## PLAT COMMITTEE

<b>Case Number:</b>	2026-PLT-001 (Amended)
<b>Property Address:</b>	2802 Merchants Drive ( <i>Approximate Address</i> )
<b>Location:</b>	Wayne Township, Council District #11
<b>Petitioner:</b>	Emmert Group Properties LLC, by David Gilman
<b>Zoning:</b>	C-7 (FF) (FW)
<b>Request:</b>	Approval of a Subdivision Plat to be known as EGP Minor Subdivision, subdividing 13.046 acres into two (2) lots.
<b>Waiver Requested:</b>	None
<b>Staff Reviewer:</b>	Michael Weigel, Principal Planner I

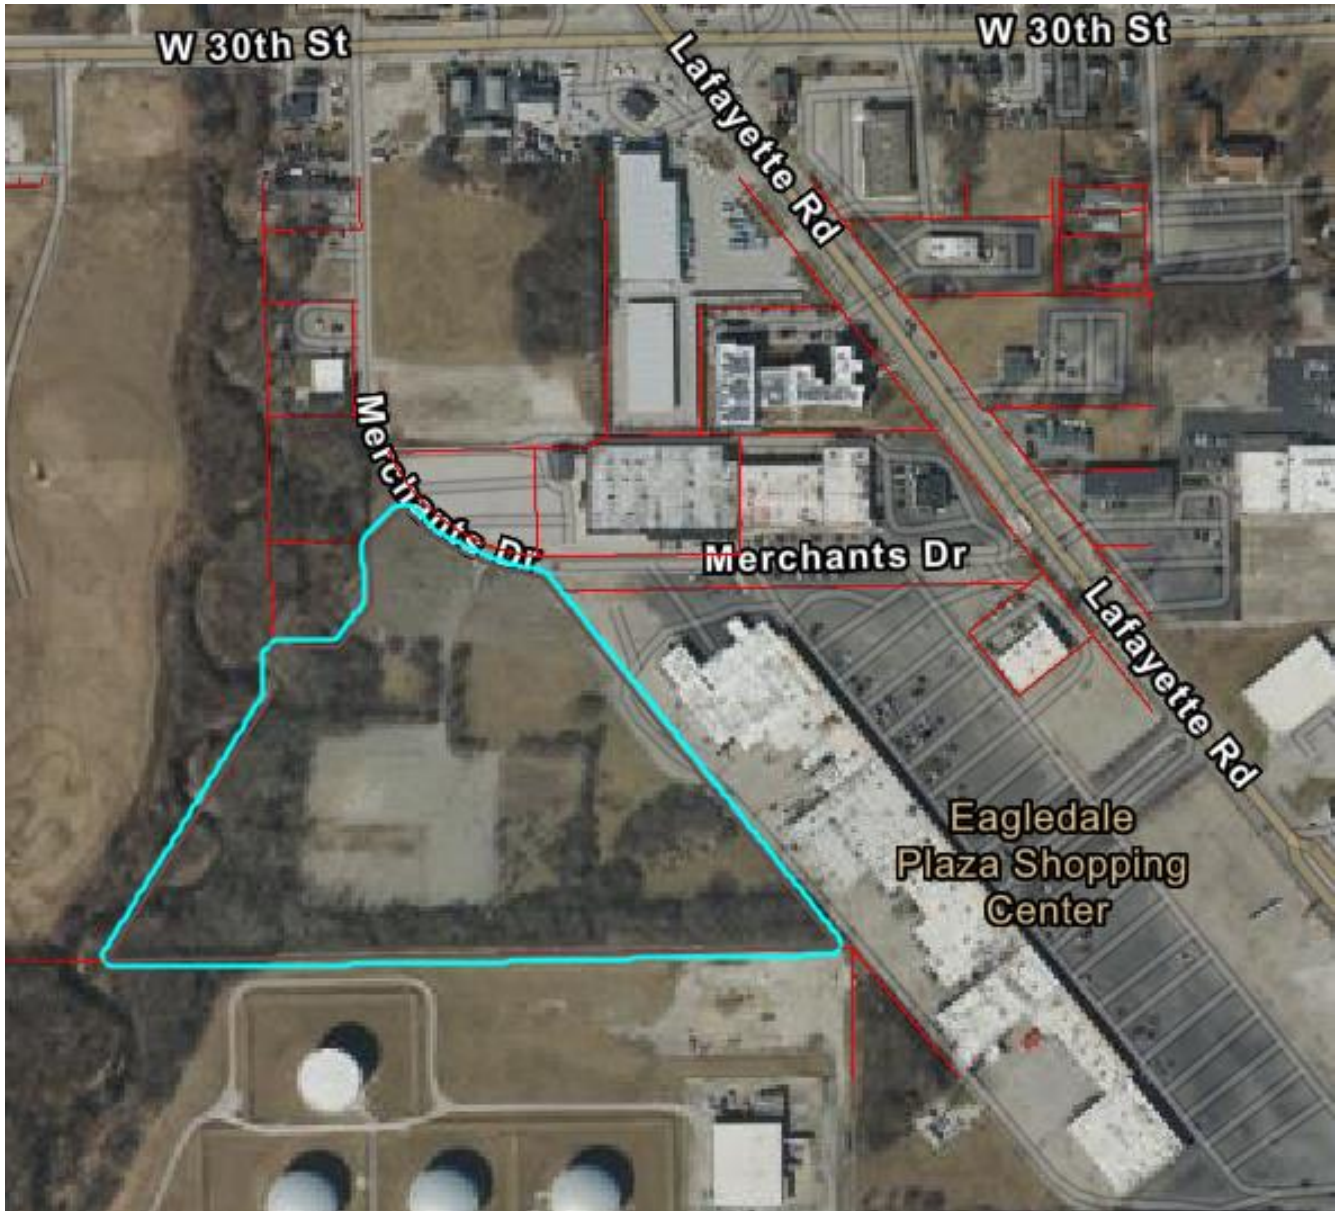
The subject site is zoned C-7 and is currently undeveloped. Portions of the property to the west fall within the Floodway and Floodway Fringe due to proximity to Little Eagle Creek to the west. The proposed plat would subdivide the parcel to create two lots per the below plat: Lot 1 would be comprised of 7.849 acres, and Lot 2 would be 5.197 acres. The proposed plat would meet the standards of the C-7 zoning district, commitments associated with the rezoning petition 2025-ZON-102, and the subdivision regulations.

Sidewalks do not currently exist along Merchants Drive. When originally filed, this petition included a request for a waiver of sidewalk requirements. However, since Merchants is a private drive, placement of new sidewalk along the frontage would not be a requirement of the platting process.

Staff recommends that the Plat Committee **approve** and find that the plat, file-dated January 2, 2026, complies with the standards of the Subdivision regulations, subject to the following conditions:
